Application for Licence Amendment

Licence Number L5529/1988/12

Application Number APP-0032171

Premises Mt Magnet Gold

Figure 1: Proposed layout 1

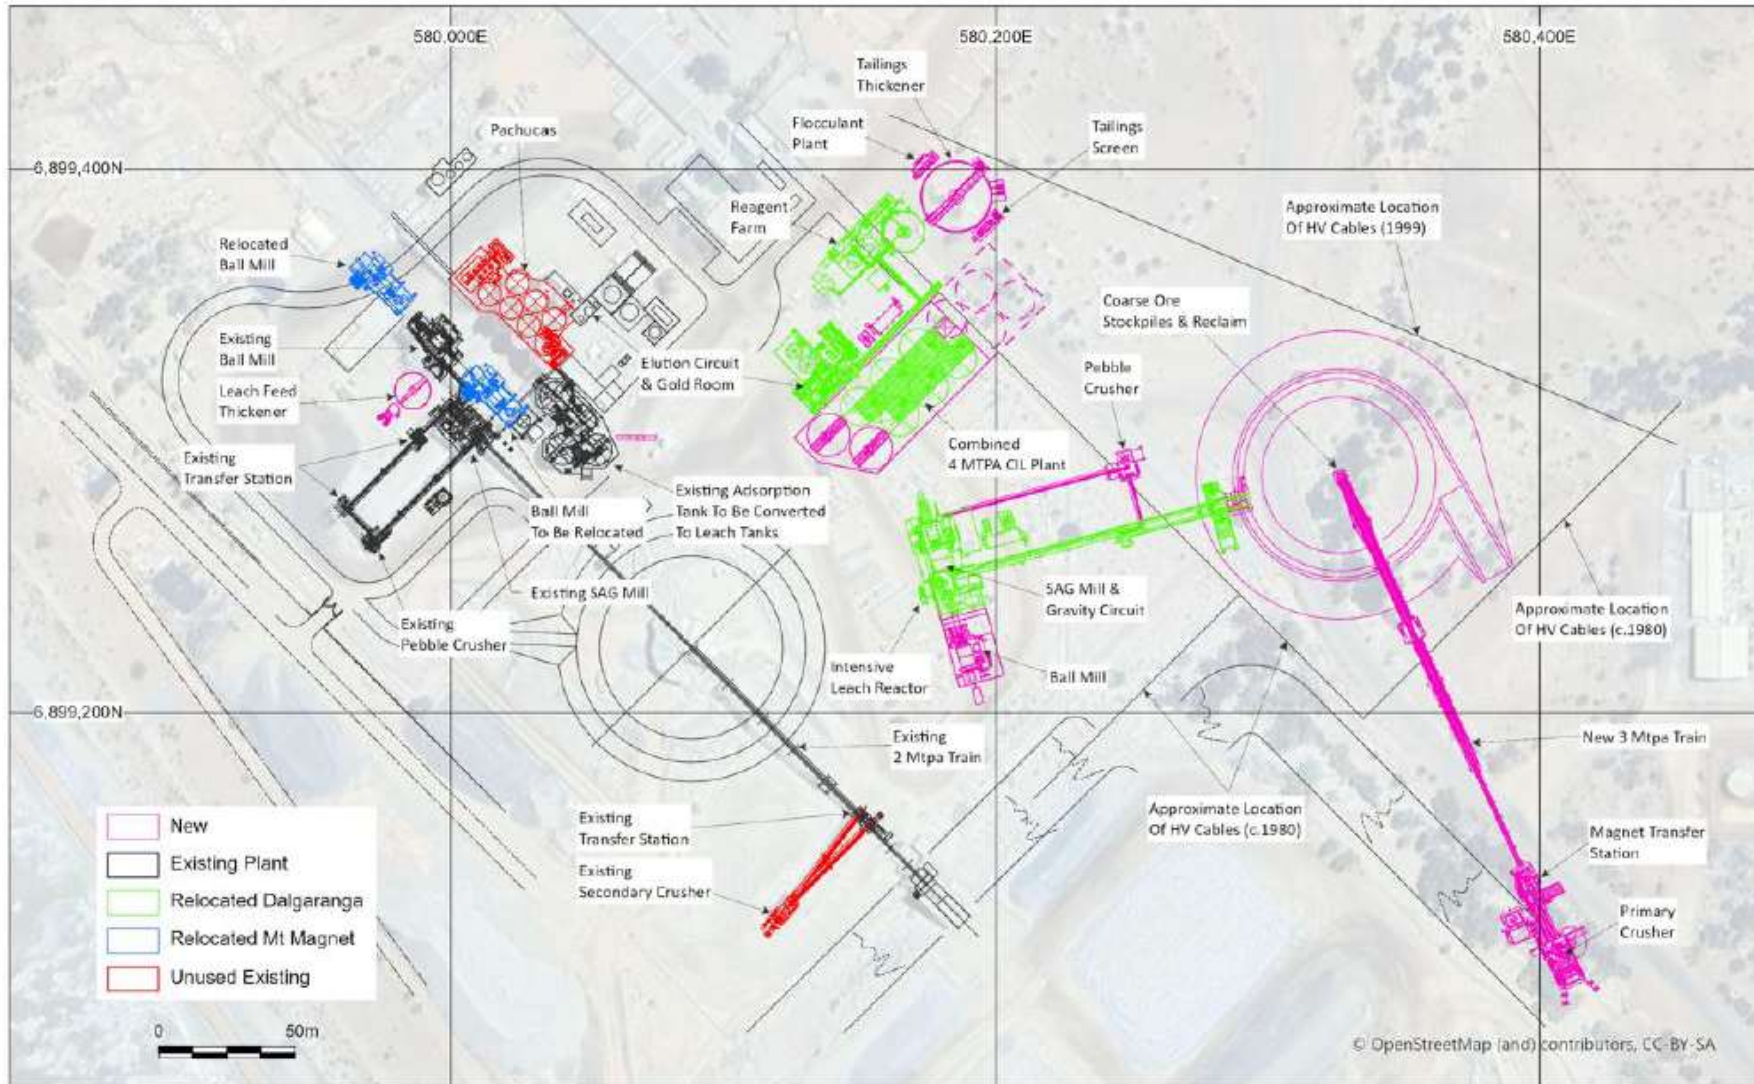
The Licence holder has requested an amendment to upgrade the ore processing at the premises from 2.4 million tonnes to 5.5 million tonnes per annual period. This will be achieved by refurbishing the existing ore processing circuit and constructing a second ore processing circuit.

The refurbishment of Circuit 1 will involve the following changes:

- A refurbished 1,650 kW ball mill will be installed and operated in parallel with the existing ball mill;
- A new leach thickener will be installed; and
- Existing 3 x 1000 m³ adsorption tanks will be converted to leach tanks.

The establishment of Circuit 2 will include the following infrastructure:

- New crushing station with C150 jaw crusher, apron feeder and vibrating grizzly screen;
- New 10,000 tonne coarse ore stockpile and reclaim feeders;
- Installation of a refurbished 6.5 MW Semi-Autogenous Grinding (SAG) mill;
- New pebble crushing circuit;
- New 3,500kW Ball mill;
- Installation of a refurbished cyclone cluster consisting of 16 Weir CAVEX 250CX10 cyclones;
- Installation of a refurbished gravity circuit and CS1000 leach reactor; and
- New 2 x 3,000 m³ capacity leach tanks.

The locations of the upgraded and new infrastructure are shown below in Figures 1 and 2.

4.2.1 (Table 4.2.1)	Include the words: <i>Trend graphs for each parameter in Table 3.4.1 must include relative data from the most recent three (3) years, where available.</i>
Schedule 1: Maps	Added the following figures: <i>Figure 7: Layout 1 of new infrastructure at the Checker Processing Plant</i> <i>Figure 8: Layout 2 of new infrastructure at the Checker Processing Plant</i> <i>Figure 9: Recovery bore locations</i>

Figure 2: Proposed layout 2

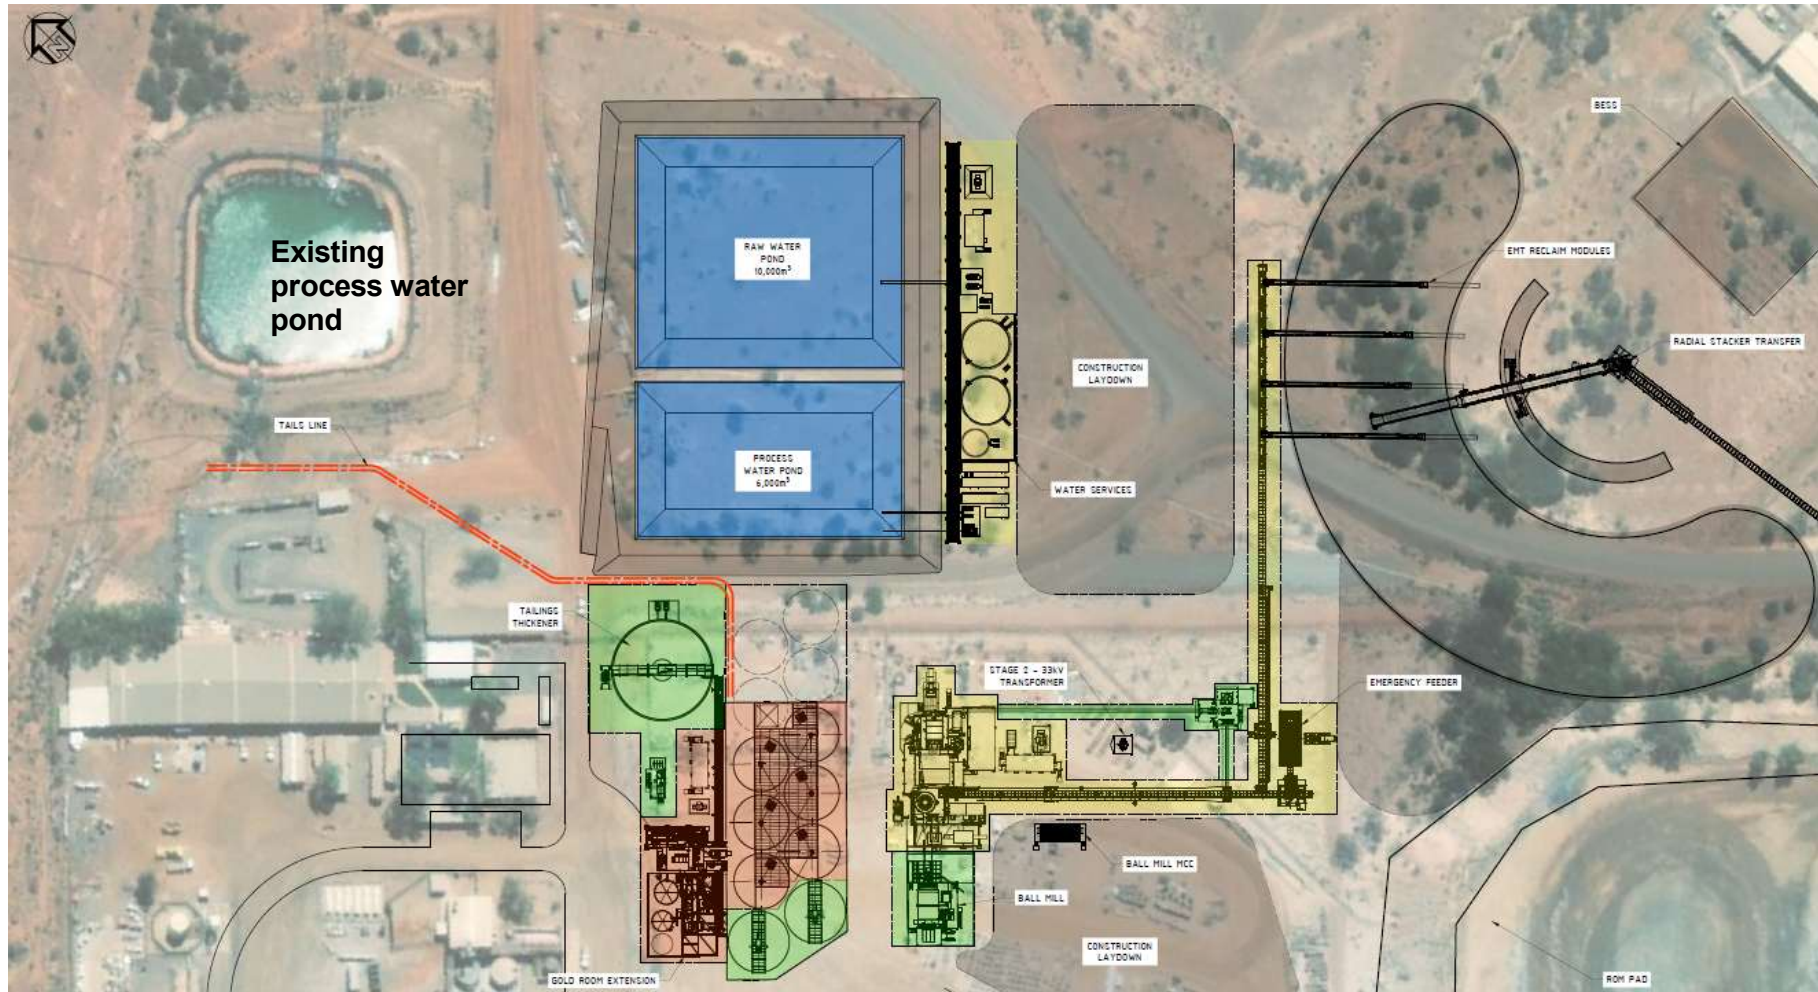
Additional service and refining infrastructure to be installed:

- 6 x refurbished 1,500 m³ adsorption stages with pumped intertank screens;
- A refurbished split Anglo American Research Laboratory (AARL) elution system with carbon regeneration;
- A refurbished gold room with electrowinning and smelting facilities will be installed to run parallel with the existing gold room;
- A new carbon safety screen;
- New Hi-Rate tailings thickener;
- New flocculant mixing and dosing system;
- 2 x new process water dams (1 x 10,000 m³ and 1 x 6,000 m³) and;
- Associated process water pipelines connecting new and existing infrastructure.

Figure 4: CTSF2 standing water levels within monitoring bores (Ref: MMG 24-25 Annual Environmental Report)

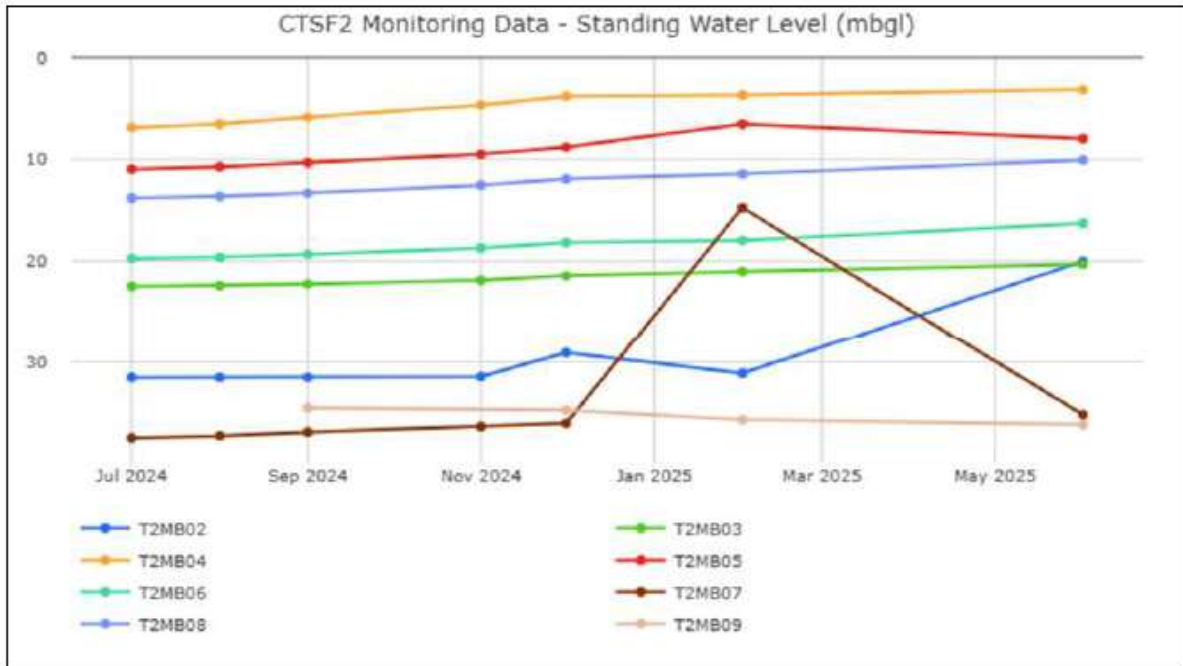
Current standing water level data from the 2024-2025 Annual Environmental Report show some rise in groundwater levels in bores south of CTSF2 and north of CTSF3, however overall levels have remained stable over the reporting period. Figure 4 and Figure 5 shows the trend in groundwater levels in bores around CTSF2 an CTSF3 over the last annual reporting period.
